Maxtor Corporation
500 McCarthy Boulevard
Milpitas, CA 95035 USA

To: T10 SAS Protocol Working Group
Contact: Mark Evans
Phone: 408-894-5310
Email: mark_evans@maxtorcom
Date: 14 January 2003

Subject: SAS definitions

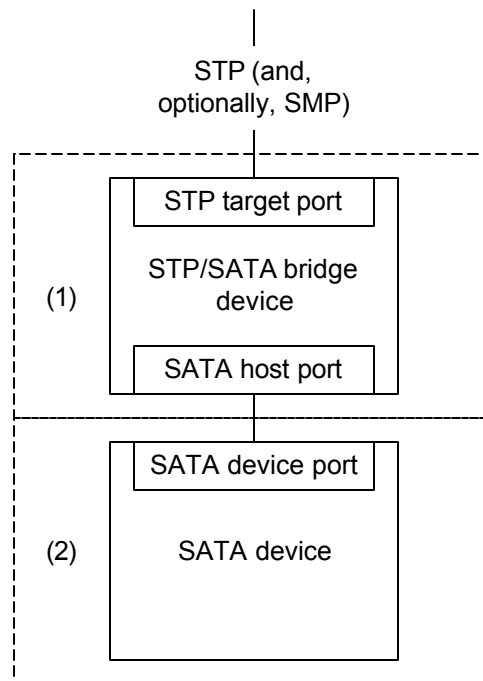
Something like the following figure should be included to illustrate an STP target device:

Note: (1) and (2) when taken together logically are a SAS target device. However, (1) may be physically contained in an expander device and (2) may be a separate SATA device, or (1) and (2) may be physically contained in a SAS target device.
